A57 Link Roads (previously known as Trans Pennine Upgrade Programme)
Planning Inspectorate Reference: **TR010034**

Peter Simon (A57L-001)

Comments on submissions for Deadlines 5 and 6

Figure 5-5 - TomTom Journey Time Routes

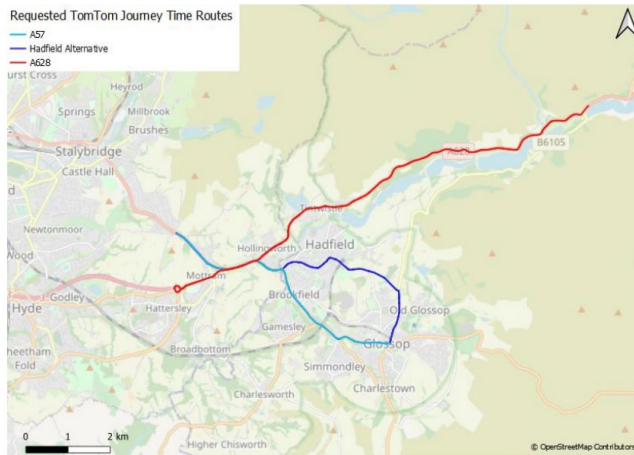
However the Figure 5.5 on P333 of the CPRE submission of collected "BBA Documents" shows quite otherwise and that in fact the Hadfield Alternative is a link

between Brookfield and the B6105 Woodhead Road of which full interim route detail is yet to be disclosed.

The specifics remain to be shown by the Applicant but this does reveal a lack of command of their own evidence and their modelling to be insufficient and confused. Such discrepancies obviously have further bearing when considering the matter of the Glossopdale AQMA compliance where doubts have been raised regarding the viability of diversions. The Applicant in answer to the WQ2 7.4 asserts they have modelled the “Worst Case Scenario” (WCS) but then I think tacitly acknowledge that they have not! Obviously the true WCS is the one yet to be modelled; – “if traffic was somehow prevented or discouraged from using Dinting Road and Shaw Lane then additional traffic modelling would need to be undertaken to understand the likely traffic redistribution effects across the road network, which would not necessarily mean that traffic flows on any alternative route, such as the A57 through Glossop (including Glossop AQMA) would increase. This is because there are likely to be wider, knock-on traffic redistribution effects”. (Page 61 “Deadline 6 Submission -9.60 Applicant’s response to Second Written Questions” 7.4)

Figure 2-6 - Journey Time Validation Routes - PCF Stage 3

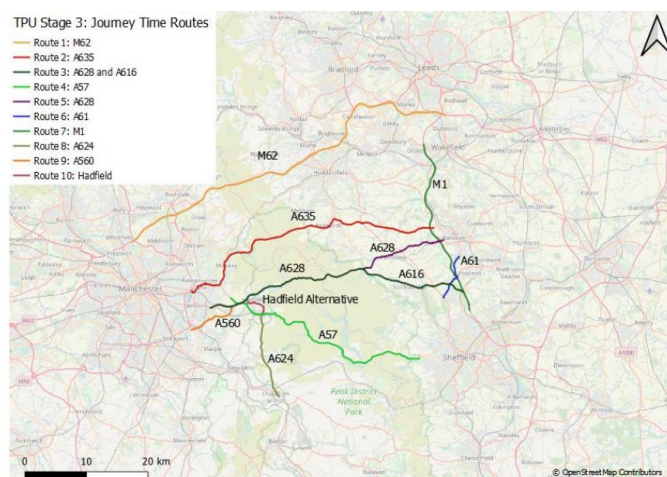
(See also Footnote *)
